**Site Address: 840 SENIOR WY SAC**  
Parcel No: 030-0194-006

**Nature of Work: TEAR OFF AND REROOF WITH TILE**

Subject: Structural Investigation Report of the Roof for the Residence located at 841 Senior Way,  
Sacramento, CA 95831.

① ROOF PLAN - CHAN.  
NT'S.

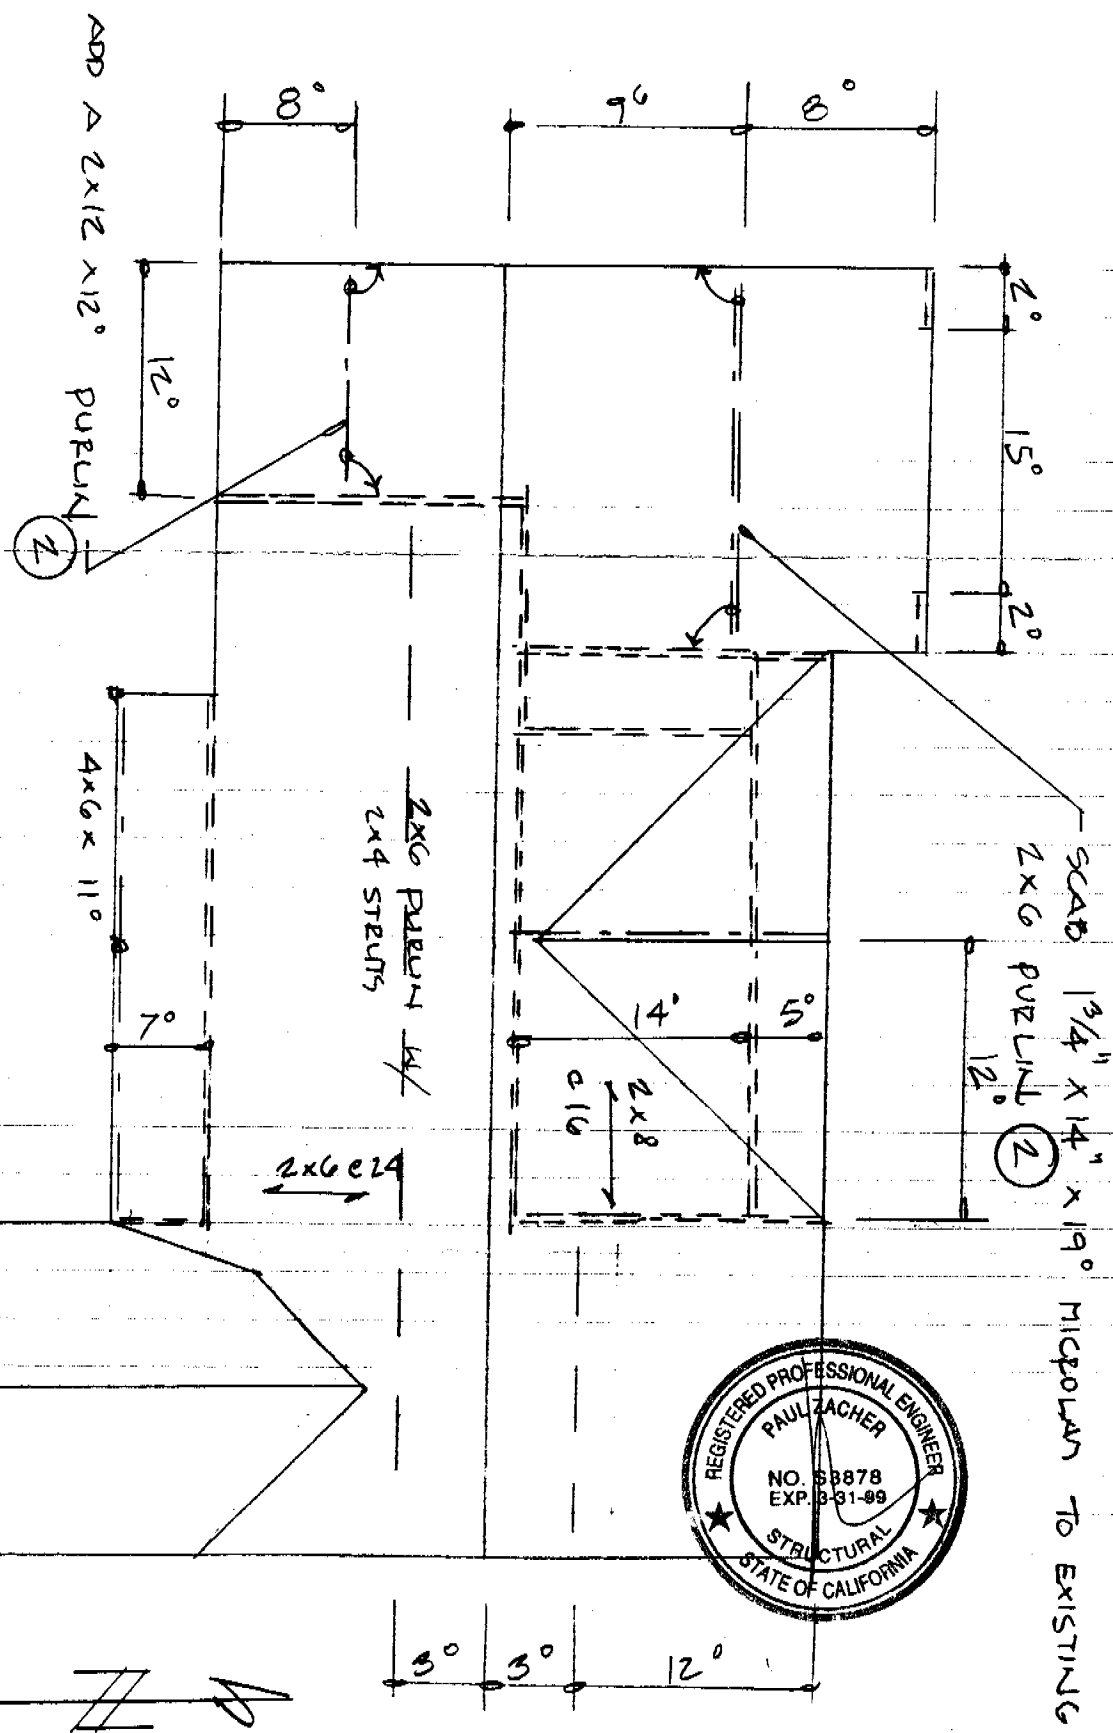
Roof:  
The living area has sufficient structural capacity for the applied live and dead loads. The garage lacks sufficient structural capacity for the applied live and dead loads.

*See struc. mods. ① & ②,  
on sheets 2, 5 & 6.  
1/6 Reviewed by Matt P. 2/7/99*

1. Scab a 1 3/4" x 11 7/8" x 19'-0" microlam purlin to the existing 2x6 purlin and nail together with 16d's @ 12" oc. Support the microlam to the bearing walls below with 2x4 struts. See details 1 and 2.
2. Add a 2x12 DF#2 x 12'-0" purlin. Support the purlin to the bearing walls below with 2x4 struts. See details 1 and 2.
